Item: TB262.1
Description: Valve Clearance Shim Range
Model Affected: Street Triple 765 RX, Street Triple R, Street Triple RS, Street Triple Moto2™ Edition, Tiger Sport 800 Tour, Trident 800

1. Original condition valve spring retainer (part number 1131090)
2. Latest condition valve spring retainer (part number 1131111)

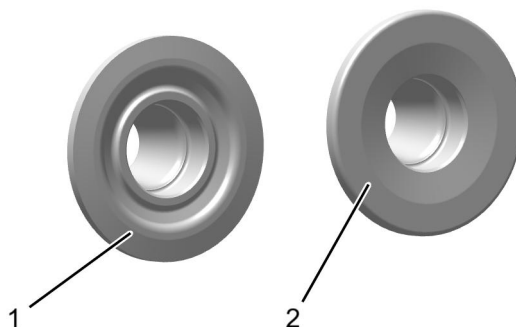
When carrying out the valve clearance adjustment and the shims listed above are required for correct valve clearance, check to see if the original condition valve spring retainer is fitted (part number 1131090), or the latest condition valve spring retainer is fitted (part number 1131111).

See the image below showing the original and latest condition valve spring retainers.

If the original condition valve spring retainer is fitted (part number 1131090), it must be replaced with the new condition spring retainer (part number 1131111) before using the shims listed in the table above.
If one original condition valve spring retainer is to be replaced, replace all valve spring retainer and shims.
If the valve clearance can not be achieved, contact Triumph Motorcycles Limited.
